PD Inrush 33.3.7.3 cleanup v131

Info (not part of baseline)

33.3.7.3 Input inrush current

Timing overview:

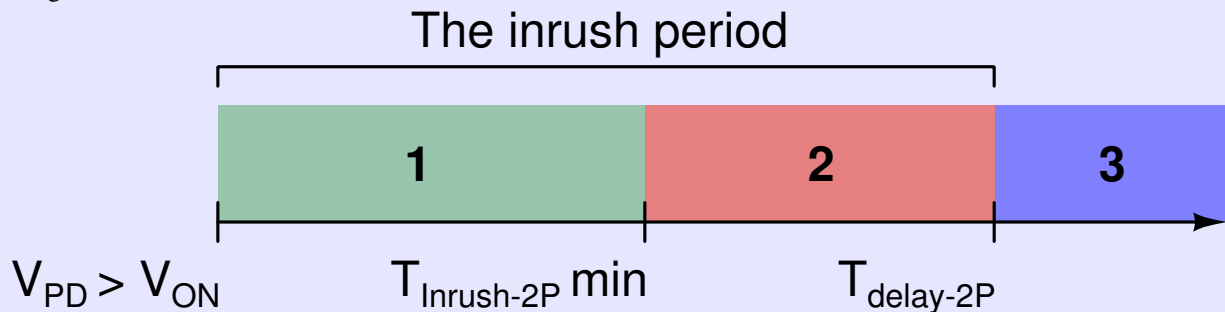
What are the real requirements on PDs in each of these periods ?

1. This is the time between the crossing of V_{On_PD} and $T_{Inrush-2P} \text{ min}$ later. There are no specific requirements for PDs during this time. Inrush is limited by the PSE during this period.

2. This is the time between $T_{Inrush-2P} \text{ min}$ and $T_{delay-2P}$. PDs need to make sure they have taken control of the input current and restrict it to less than I_{Inrush_PD} and I_{Inrush_PD-2P} . This requirement also encapsulates that a PD may not switch to a high power state (it cannot do so without violating I_{Inrush_PD} and I_{Inrush_PD-2P}).
In addition there is a quirk that assigned Class 1,2 and 3 PDs need to take into account. They are required to restrict their power consumption below P_{Class_PD} or P_{Class_PD-2P} because the PSE may already enforce Class power at $T_{Inrush-2P} \text{ min}$.

3. Finally, this is the time after $T_{delay-2P}$. After this time the PSE is guaranteed to be in `POWER_ON` and the PD needs to follow the normal rules of `MDI_POWER2`.
